Service Bulletin

Bulletin No.: P11075

Subject: Locking Fuel Tank Filler Door Not Locking/Unlocking

Models: 2010-2014 Cadillac SRX with RPO N08

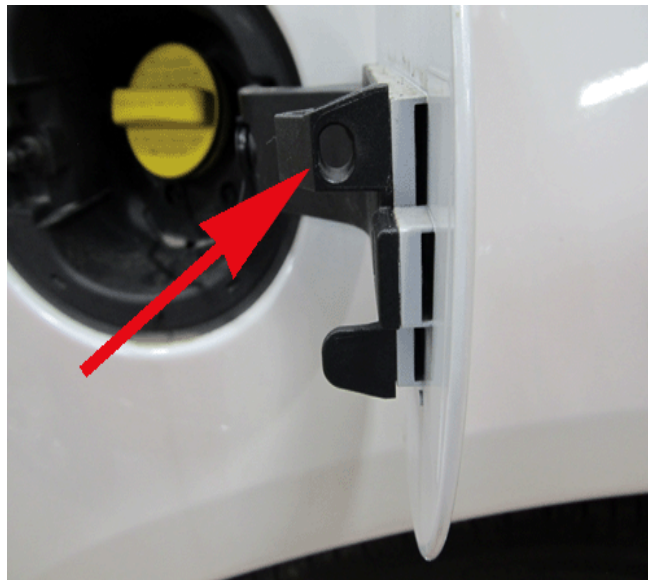
Some customers may comment that the locking fuel tank filler door does not lock or unlock. This concern may be intermittent.

This condition may be caused by the alignment of the locking pin to the hole in the fuel tank filler door bracket being off center, preventing full engagement of the locking pin.

3629547

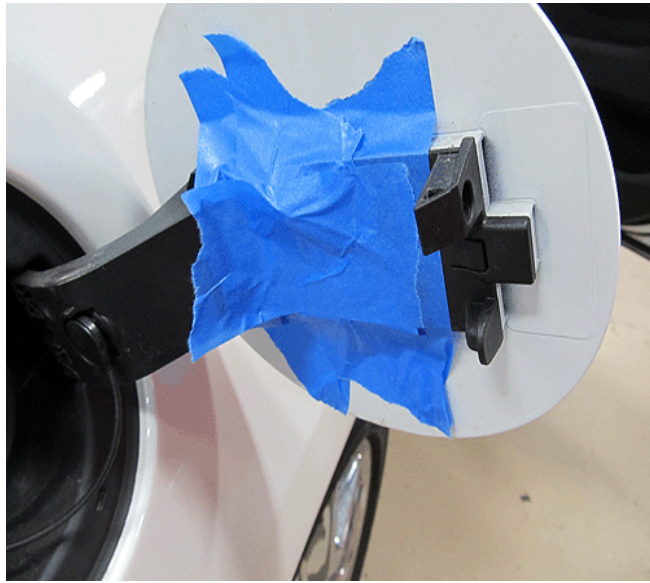
2. Locate the oval shaped locking pin engagement hole on the inner fuel tank filler door.

3629551

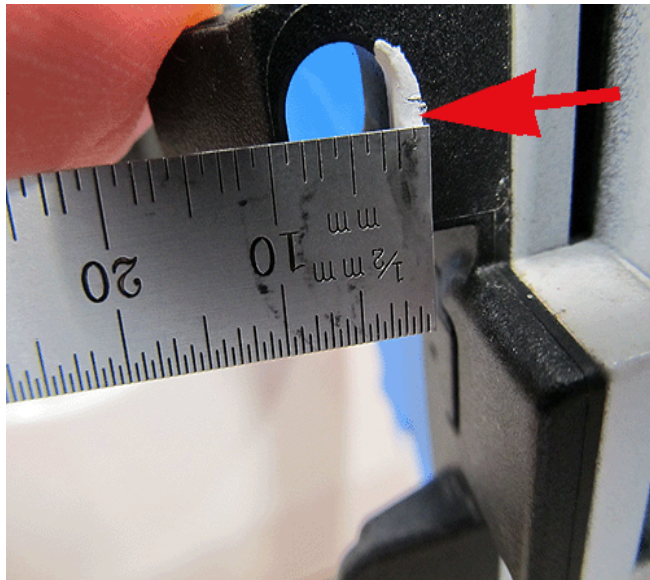
3. Protect the inside of the fuel tank filler door with masking tape as shown.

3629554

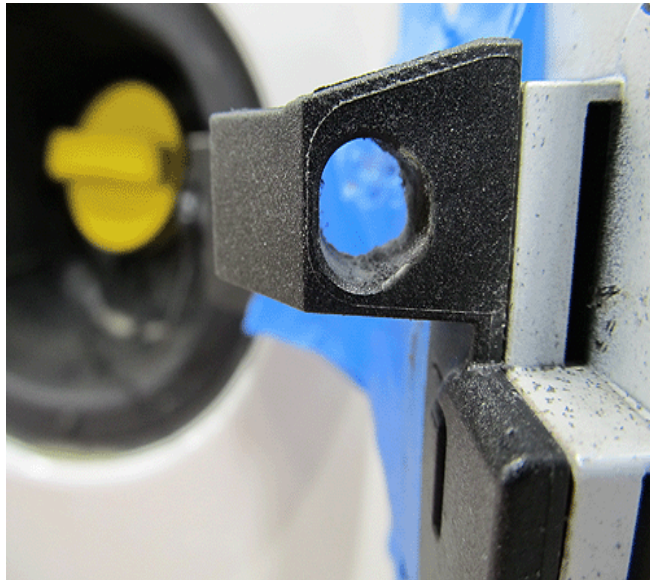
4. Using a paint pen, mark a 2.0 mm area on the fuel tank filler door bracket as shown. Ensure the area that is marked is toward the painted side (outside) of the door.
